# Access Compliance Report

## Public Rights-of-Way

Intersection ID: 11000	Main Street: NC_MUSIC_FACTORY_BV	Cross Street: JOHNSON_ST	Location: E
ADA ID: CA7A688C8285	Ramp Type: Directional1	Initial Pass/Fail: Fail	Overall Compliance: No
Codes/Mitigation Info/Possible Solution		Field Measurements/Component Compliance	
Severity Score: 13.75

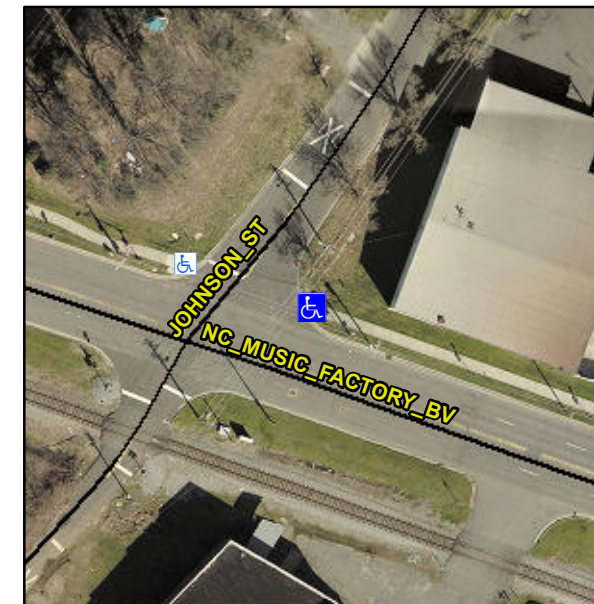
**R304.2.2, R304.5.3**

Compliance	Description	Data	Compliance	Description	Data
N/A	Ramp Length (in)	80.0	N/A	Grade Break?	N/A
Yes	Ramp Width (in)	70.0	N/A	Grade Break Slope (%)	0.0
No	Ramp Slope (%)	11.7	N/A	Grade Break XSlope (%)	0.0
No	Ramp XSlope (%)	2.6			
N/A	Flare Type LT	N/A	N/A	Flare Type RT	N/A
N/A	Flare Slope LT (%)	N/A	N/A	Flare Slope RT (%)	0.0
N/A	Flare Traversable LT?	N/A	N/A	Flare Traversable RT?	N/A
N/A	Landing Length (in)	0.0	N/A	DWS Provided?	N/A
N/A	Landing Width (in)	0.0	N/A	DWS Contrast?	N/A
N/A	Landing Slope (%)	0.0	N/A	DWS Length (in)	N/A
N/A	Landing X Slope (%)	0.0	N/A	DWS Full Width?	N/A
N/A	Landing Curb? (Y/N)	N/A	N/A	DWS Offset LT (in)	N/A
N/A	Shared Landing?	N/A	N/A	DWS Offset RT (in)	N/A
N/A	Gutter Ponding?	0.0	N/A	Gutter Slope (%)	N/A
N/A	Gutter Lip Ht (in)	0.0	N/A	Gutter X Slope (%)	N/A
N/A	Painted X Walk1?	No		Road Slope (%)	0.6
	X Walk 1 Direction	To W		Road X Slope (%)	8.5
	X Walk 1 Width (in)	N/A		Clear Space?	N/A

**Remove & Replace Entire Ramp.**
